Public Service  
Company of Colorado

May 27, 1988  
Fort St. Vrain  
Unit No. 1  
P-88184

SUBJECT: Technical Specification  
Upgrade Program, Revised  
Final Draft Submittal

Attached is the revised Final Draft of the upgraded Fort St. Vrain (FSV) Technical Specifications. These specifications are submitted for your review as a Proof and Review draft.

Figure 2.2.1-1

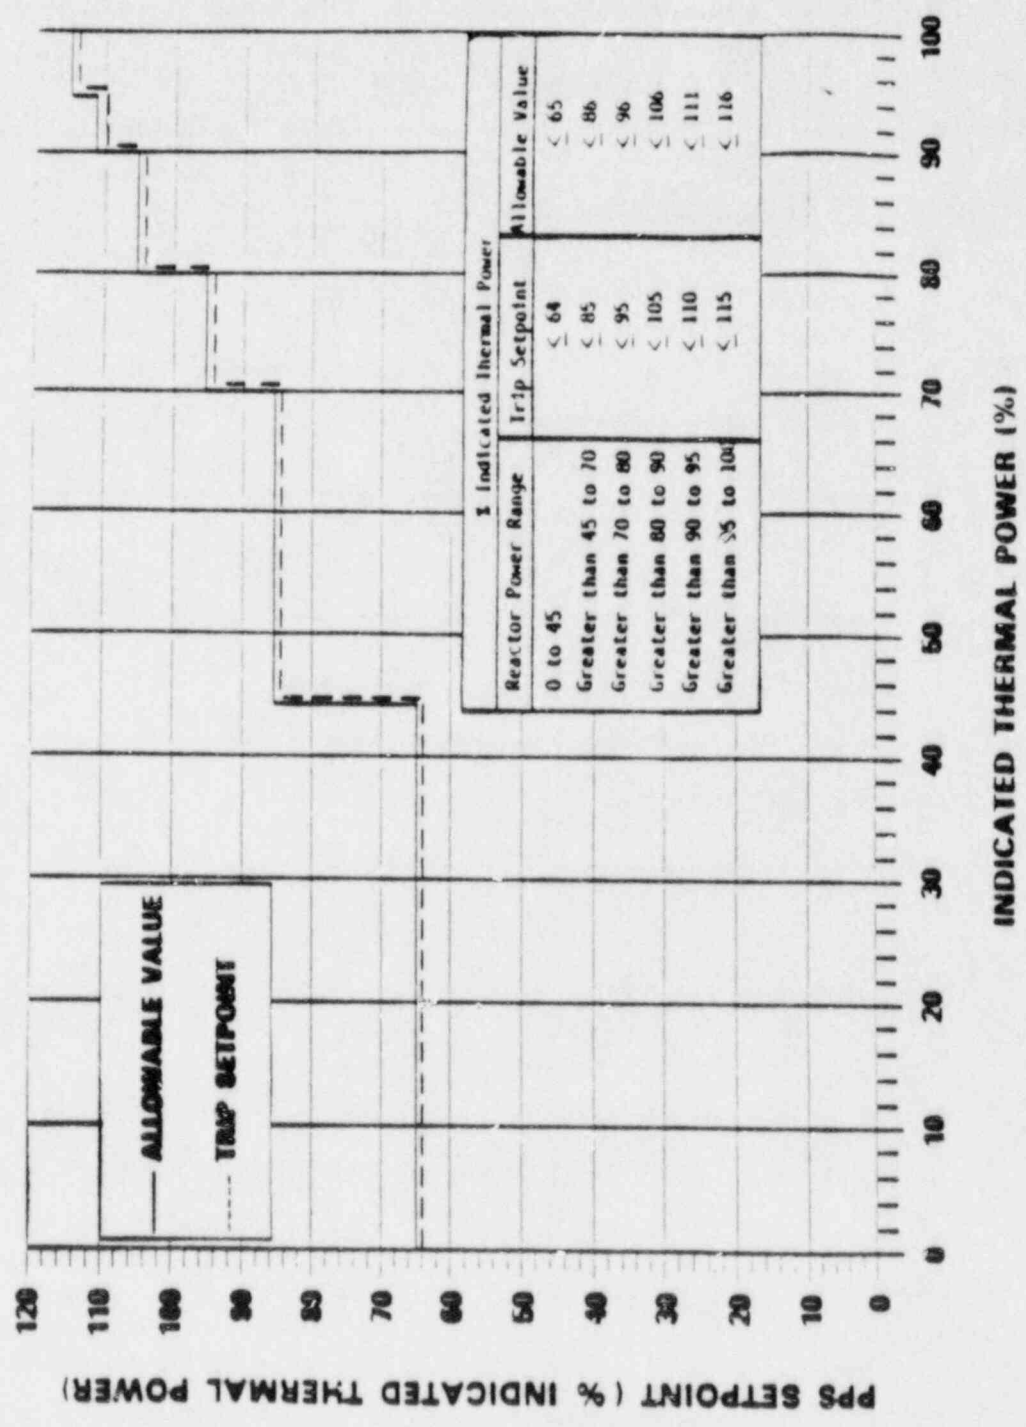
LSSS 2.2.1 - Added ACTION b to allow 12 hours to adjust the setpoint of the Linear Channel - High Neutron Flux channel if required by a power level change. The detector decalibration curve, Figure 2.2.1-1, identifies different setpoints for different power levels. In the event of an unplanned power reduction from 80% to 65%, for example, a setpoint adjustment is required and 12 hours is allowed to make this change before considering the channels inoperable.

Figure 3.2.2-1

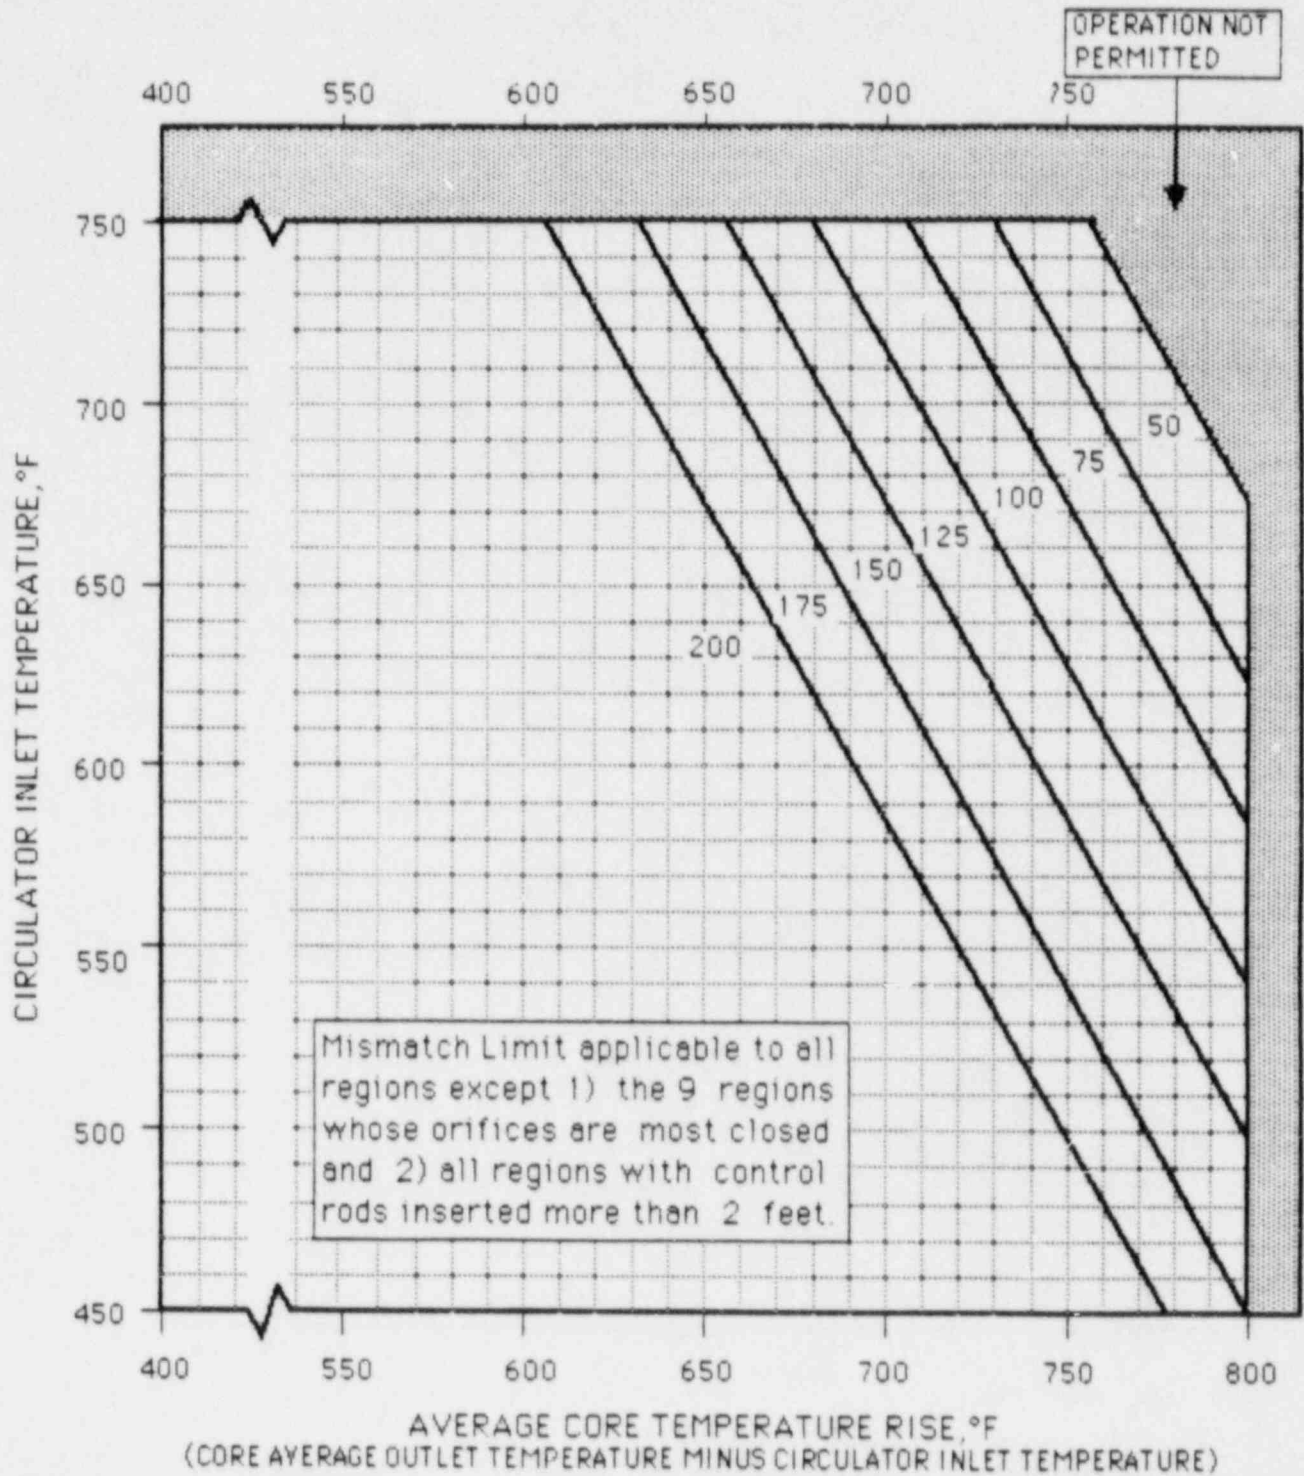
Figure 3.2.2-1 - Revised to include all expected combinations of operating parameters. Existing curves were extrapolated, making use of the same methodologies and including the same uncertainties used during their initial development. Shading is provided to preclude operation with outlet temperatures above 1555 degrees F. This revision will be addressed as a "C" category comment.

Figure 5.1-1

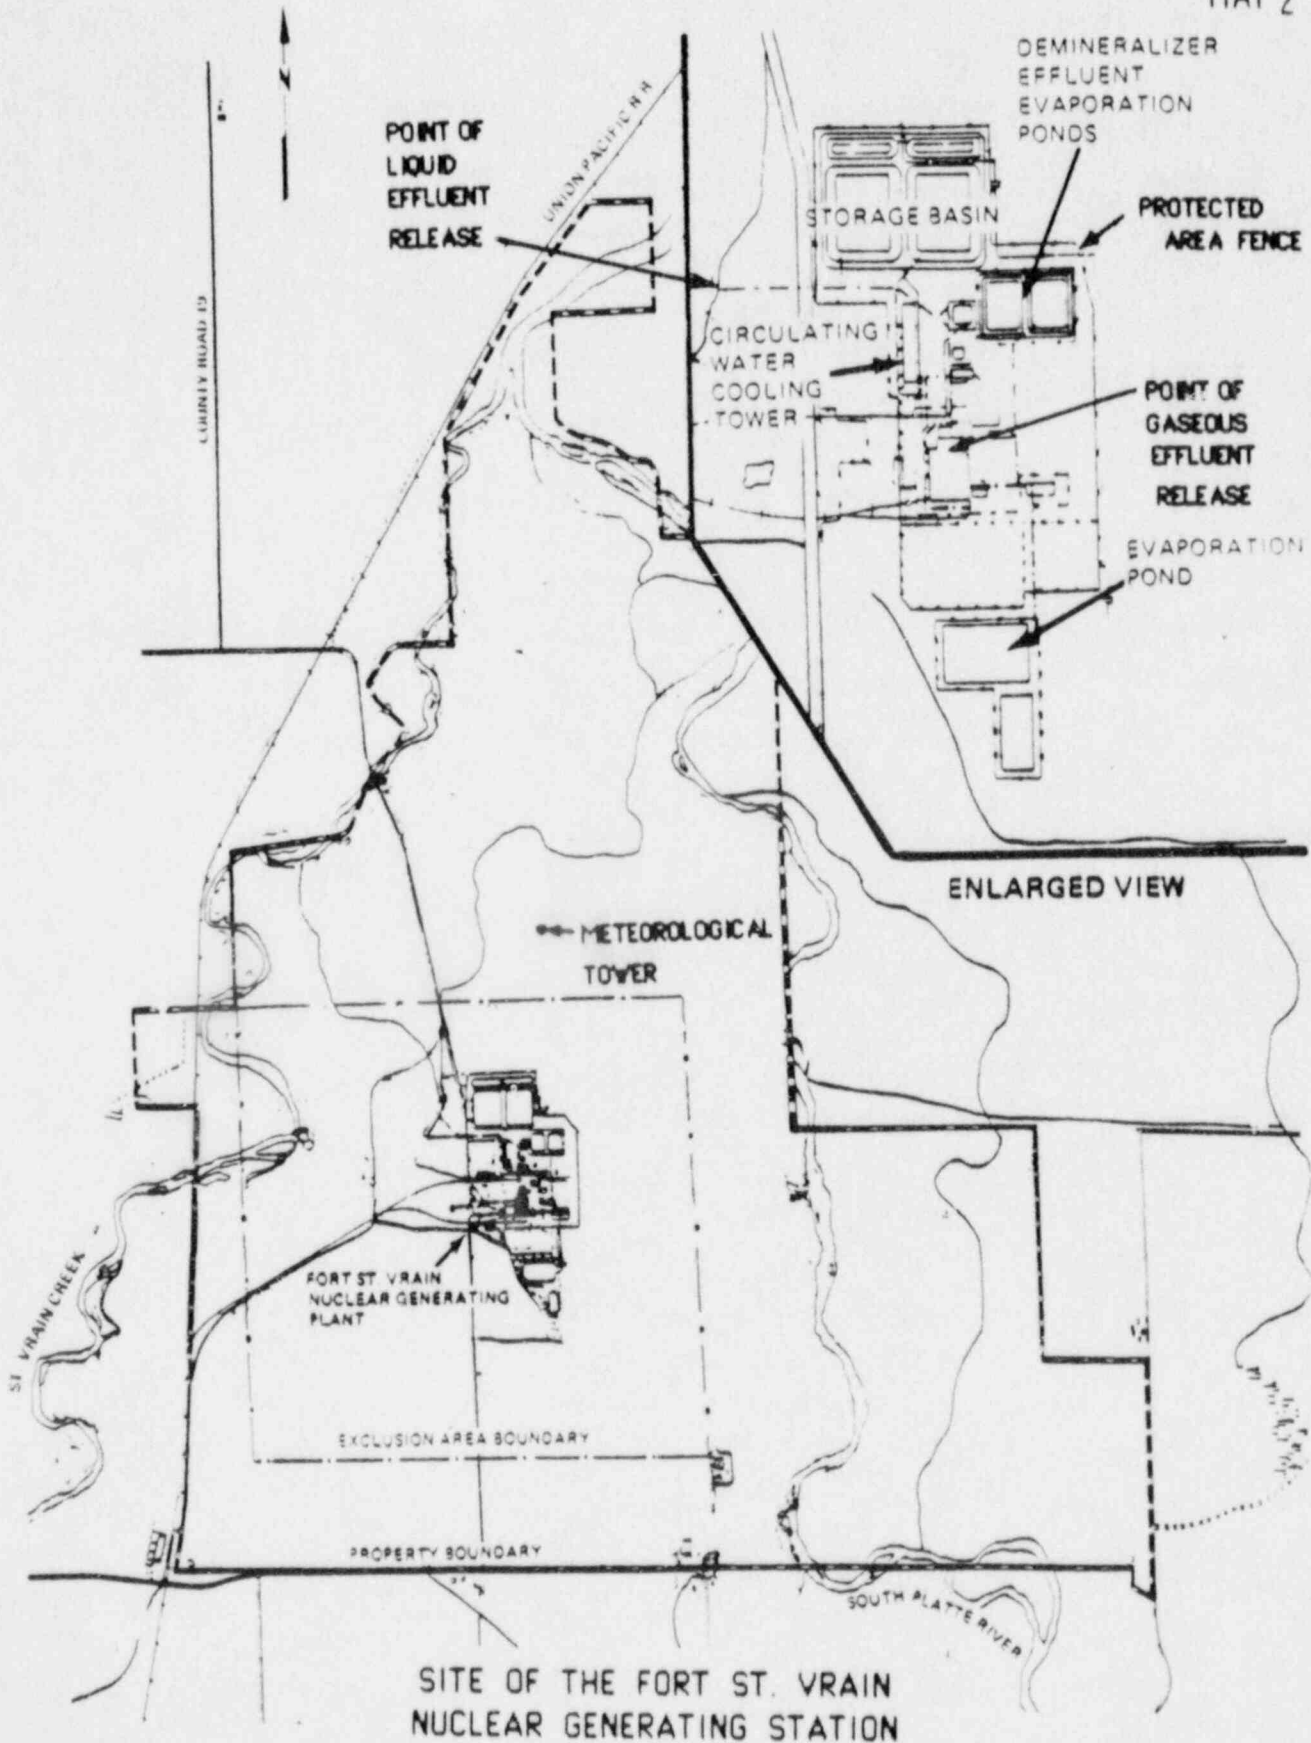
Figure 5.1-1 - Revised to reflect effluent release points.
